Project Name: Ginko Storage

Description: Final site plan approval

RE: **Ginko Self Storage -Final Site Plan/Final Engineering Plan Review-4th Review**
~~Stormwater Maintenance Agreement Review-1st Review~~

Revised Final Site Plan Review for Special Land Use for White Lake Charter Township, Michigan

DRAWING TITLE
UTILITY PLAN

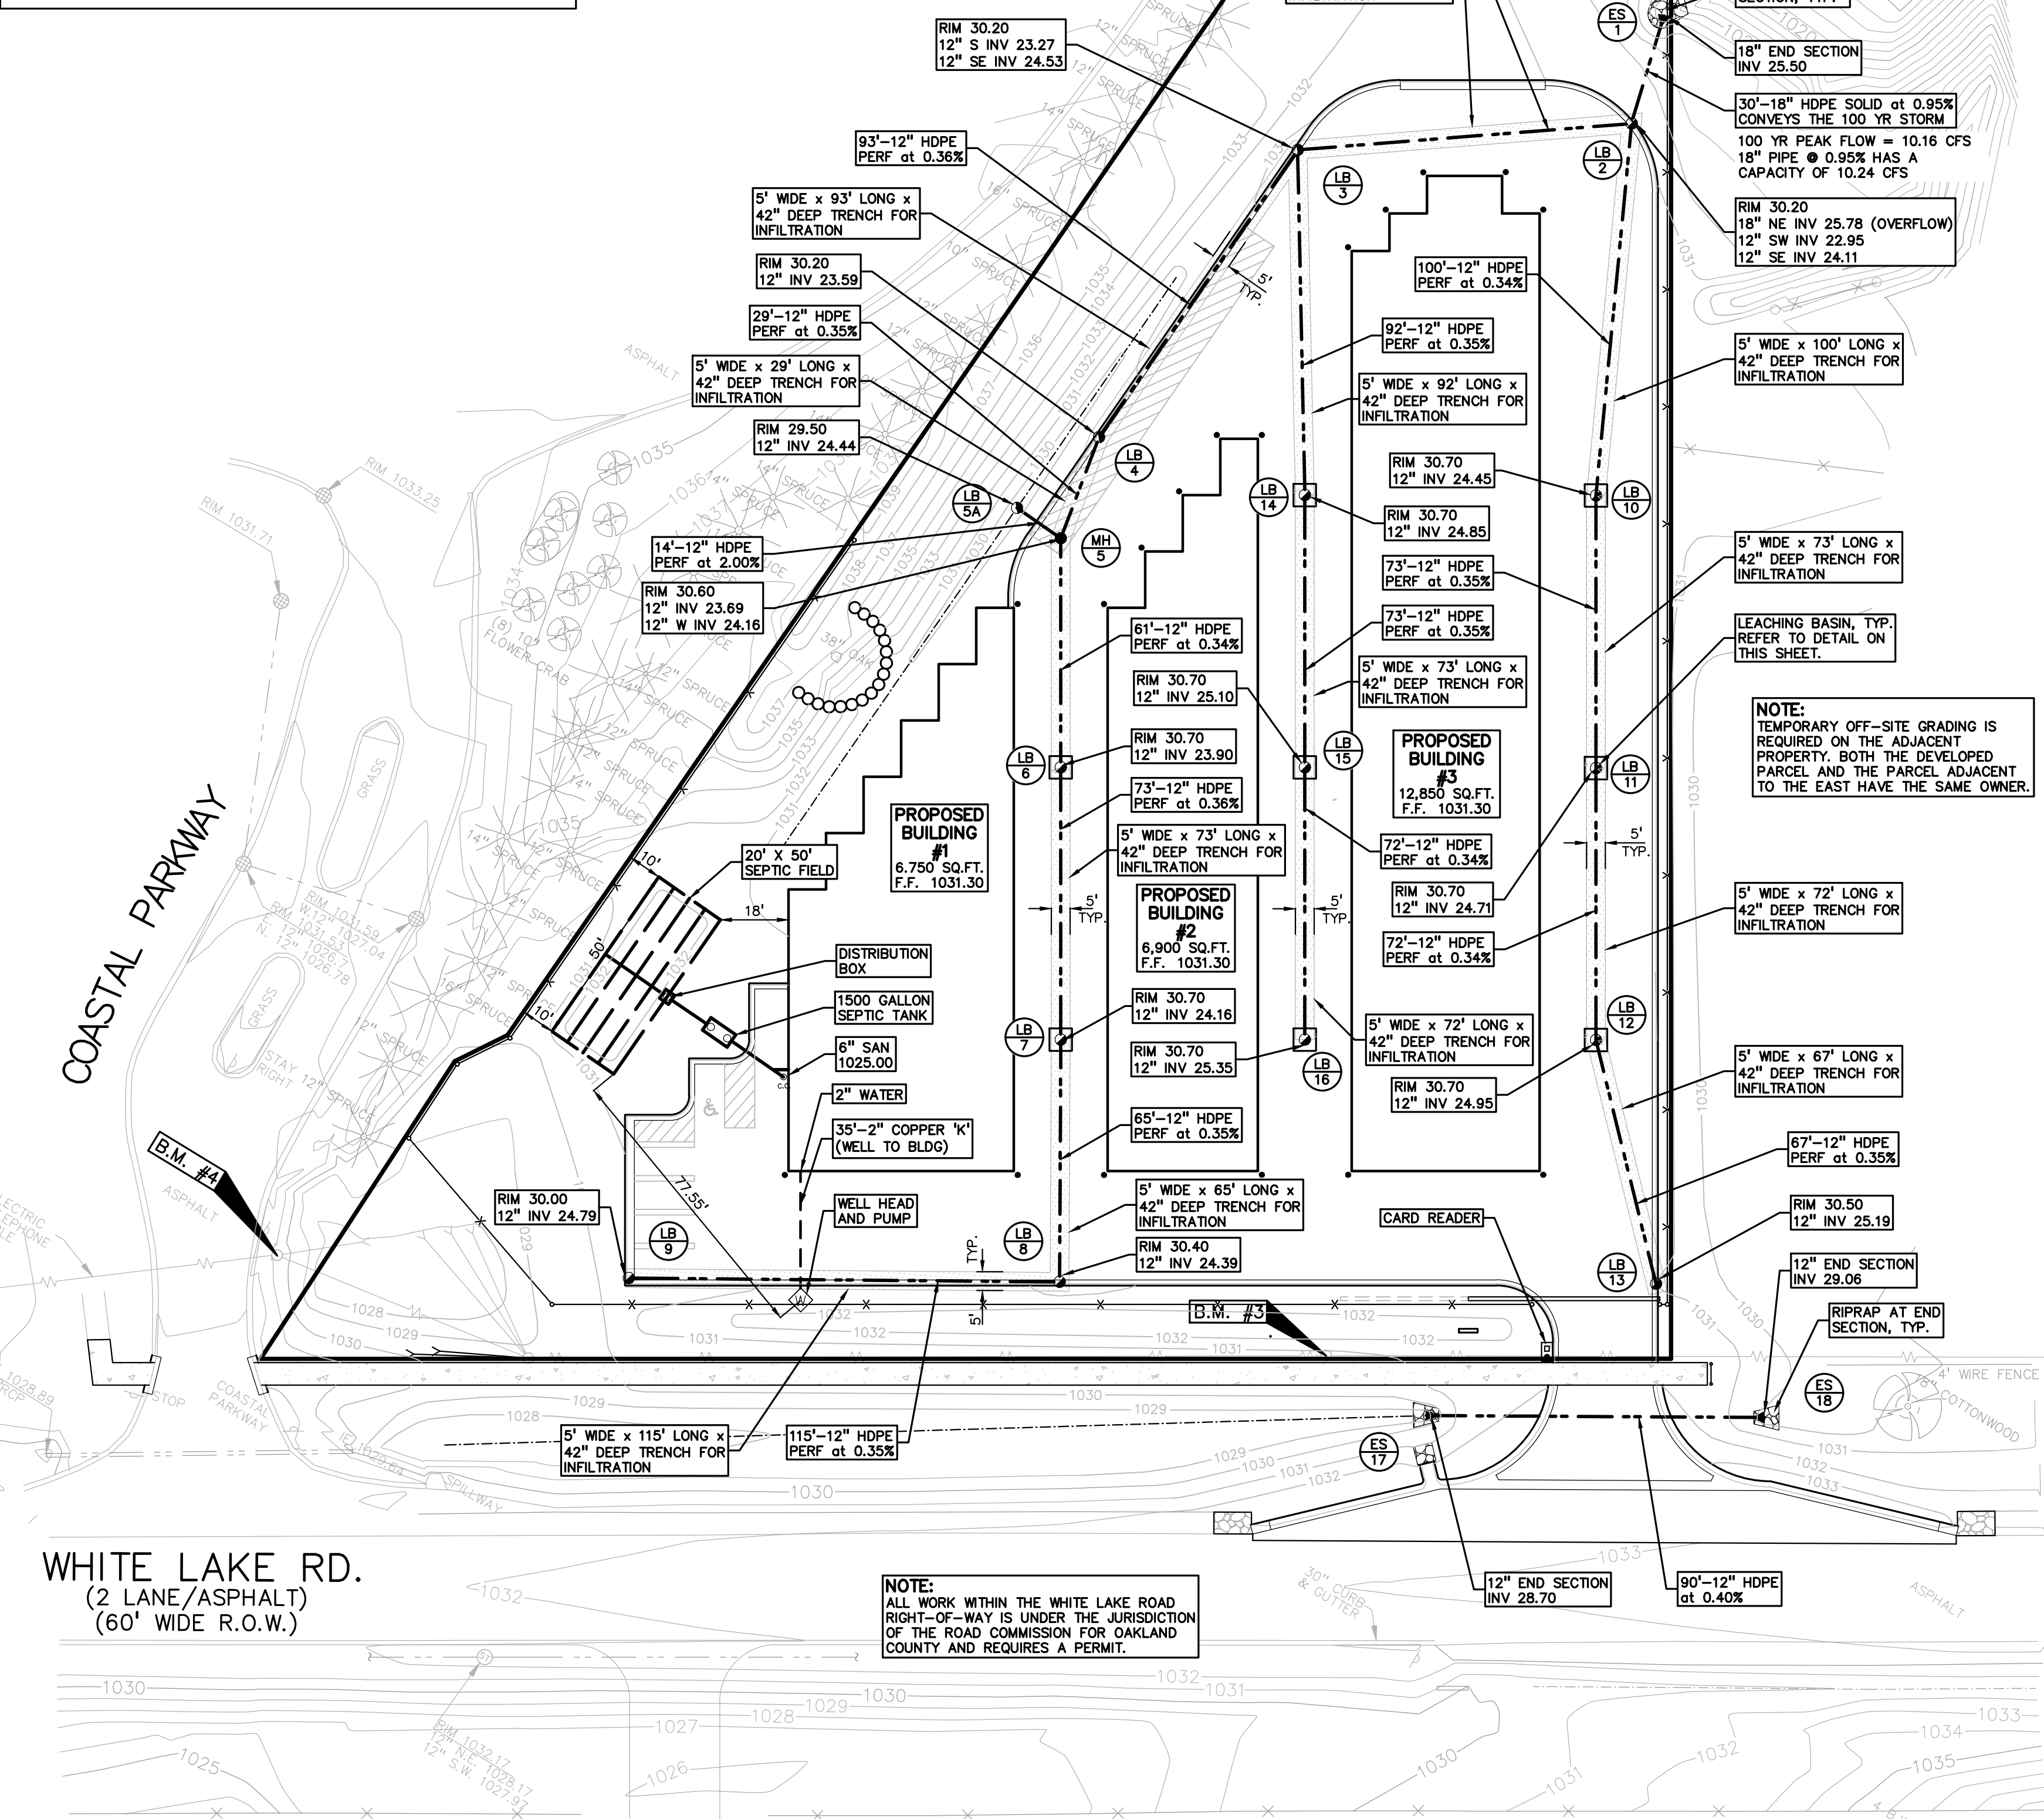
1. Sheet C-6.0- Provide storm outlet note that was on this previous plan sheet.
2. Sheet C-6.0-Provided pipe volume calculations- LF of pipe (1010') appears in error due to plan revisions. We calculate 1088' Please verify and revise calculations as necessary.
